Project	IEEE 802.16 Broadband Wireless Access Working Group < http://ieee802.org/16 >	
Title	Modified DL subcarrier to resource unit mapping	
Date Submitted	2008-07-07	
Source(s)	Taeyoung Kim Jeongho Park Junsung Lim Jaeweon Cho Hokyu Choi Heewon Kang Samsung Electronics Sophie Vrzic Dongsheng Yu Mo-Han Fong Robert Novak Steve Yuan Hosein Nikopourdeilami Nortel	ty33.kim@samsung.com , jeongho.jh.park@samsung.com , junsung.lim@samsung.com jaeweon.cho@samsung.com , choihk@samsung.com hkang@samsung.com svrzic@nortel.com dongshengyu@nortel.com mhfong@nortel.com rnovak@nortel.com junyu@nortel.com hosein@nortel.com
Re:	IEEE 802.16m-08/024, "Call for Comments and Contributions on Project 802.16m System Description Document (SDD)". Target topic: "DL Physical Structure"	
Abstract	This contribution provides the modified text for Downlink subcarrier to resource unit mapping (sub-clause 11.5.2.2) in the IEEE 802.16m SDD

Modified DL subcarrier to resource unit mapping

Figure 1 – Proposed DL subcarrier to resource unit mapping structure

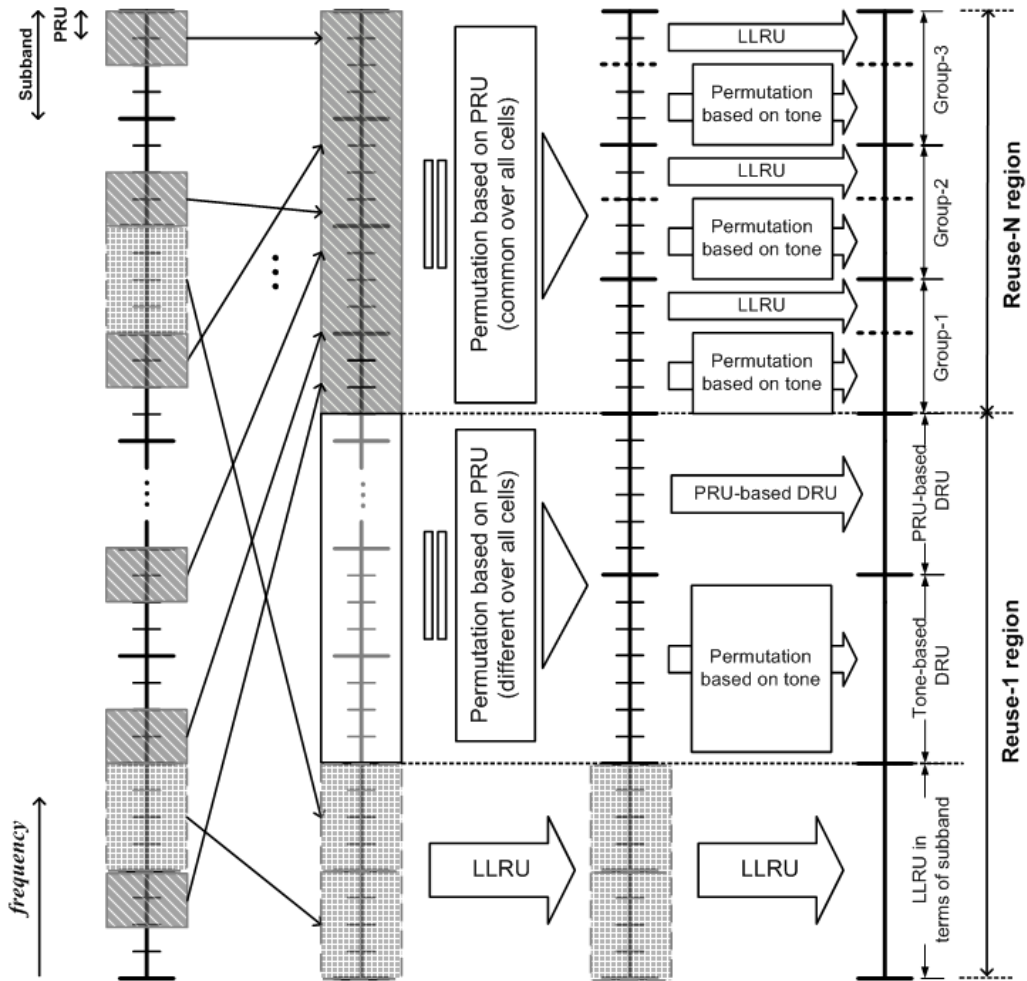
In order to meet the requirements mentioned above, a modified DL subcarrier to resource unit mapping is proposed as described in Figure 1.

- Firstly assign the resource units for frequency reuse-N region as the unit of 1 PRU. The location for frequency reuse N region shall be predefined according to the ratio of FFR ratio index which is given by Broadcast Channel (BCH) as defined in 11.6.2.2 [TBD].

- Reserve the resource units for LLRUs in the frequency reuse-1 region as the unit of subband defined as the consecutive 4 PRUs, except for the assigned resource units for frequency reuse-N region in the previous step. The localized resource units shall be located at the specific region, which is predefined according to the number of LLRUs in frequency reuse-1 region which is given by BCH [TBD].

- Within the resource units in each frequency reuse-N region, apply the renumbering and inter-cell permutation as the unit of 1 PRU. The inter-cell permutation shall be common between the neighbor cells/sectors using fractional frequency reuse. After applying the permutation based on PRU, the procedure to make the groups for each cell/sector shall be performed. The resource within each group shall be divided into LLRU and DRU using the PRU as the unit. At each group, different resource unit mapping can be applied

- Within the remaining resource units (e.g. for distributed resource in frequency reuse-1 region) after assigning resource units for frequency reuse-N region and LLRUs for frequency reuse-1 region, apply the renumbering and intra-cell permutation as the unit of 1 PRU. Each cell/sector has the different intra-cell permutation sequences with the cell/sector specific information. After applying the permutation based on 1 PRU, PRU-based DRUs in frequency reuse-1 region shall be selected among the assigned PRUs. With the remaining PRUs, the permutation based on tone shall be performed to make tone-based DRUs in frequency reuse-1 region.

Figure 1 Illustration of the downlink subcarrier to resource **block-unit** mapping

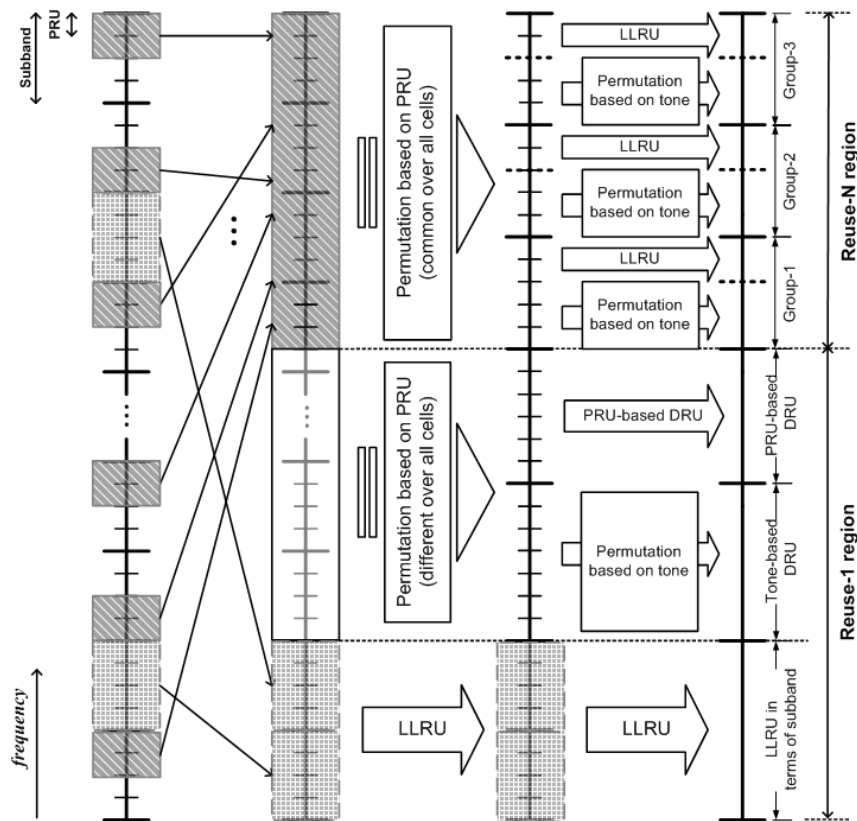
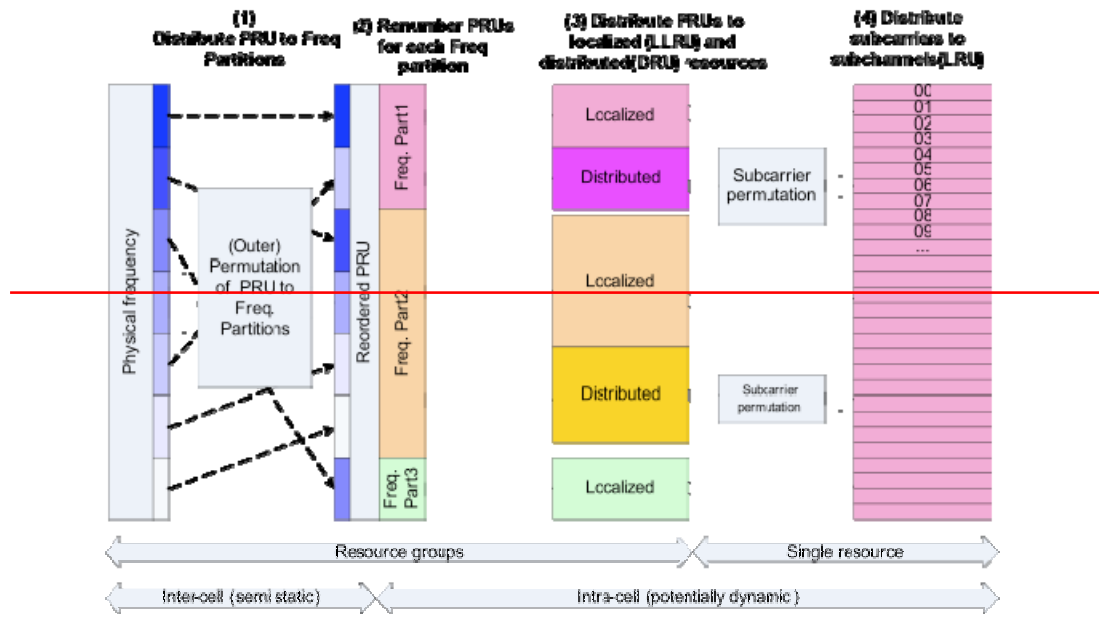
- ~~1. First level or outer permutation is applied to the PRUs in the units of N PRUs, where N is TBD;~~
- ~~2. Distributing (TBD) the reordered PRUs into frequency partitions.~~

- ~~3. The frequency partition is divided into localized (LLRU) and/or distributed (DRU) resources using the PRU as unit for each resource. The sizes of the groups are flexibly configured per sector (TBD). Adjacent sectors do not need to have same configuration of localized and diversity groups;~~

- ~~4. The localized and distributed groups are further mapped into LRUs (by direct mapping of LLRU and by "Subcarrier permutation" on DRUs) as shown in the following figure.~~

1. Firstly assign the resource units for frequency reuse-N region as the unit of 1 PRU. The location for frequency reuse-N region shall be predefined according to the ratio of FFR ratio index

2. Reserve the resource units for LLRUs in the frequency reuse-1 region as the unit of subband defined as the consecutive 4 PRUs, except for the assigned resource units in frequency reuse-N region in the previous step. The localized resource units shall be located at the specific region, which is predefined according to the number of LLRUs in frequency reuse-1 region.

3. Within the resource units in each frequency reuse-N region, apply the renumbering and inter-cell permutation as the unit of 1 PRU. The inter-cell permutation shall be common between the neighbor cells using fractional frequency reuse. After applying permutation based on PRU, the procedure to make the groups for each sector shall be performed. The resource within each group shall be divided into LLRU and DRU using the PRU as the unit. At each group, different resource unit mapping can be applied

4. Within the remaining resource units (e.g. for DRU in frequency reuse-1 region) after assigning resource units for frequency reuse-N region and LLRUs in frequency reuse-1 region, apply the renumbering and intra-cell permutation as the unit of 1 PRU. Each cell has the different intra-cell permutation sequences with the cell specific information. After applying permutation based on 1 PRU, PRU-based DRUs in frequency reuse-1 region shall be selected among the assigned PRUs. With the remaining PRUs, the permutation based on tone shall be performed to make tone-based DRUs in frequency reuse-1 region.
